Kit with starter clutch for Testastretta 11° 1200cc and Testastretta DVT engines

Testastretta 11° 1200cc – Testastretta DVT 1200cc
– Testastretta DVT 1262cc
Service Bulletin SRV-SRB-19-014

Version 3:

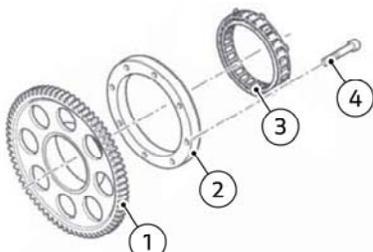
The kit with starter clutch **part no. 69928781A** is valid for the following model:

- Multistrada 1200 Model Year 2015-2016-2017 (all versions)

and consists of the following components:

Kit part no. 69928781A				
	Pos.	Description	Part no.	Qty
	1	Starting driven gear	17310351A	1
	2	Starter clutch flange	16012121B	1
	3	Starter clutch	70140541A	1
	5	Screw M6x35	77113931A	8
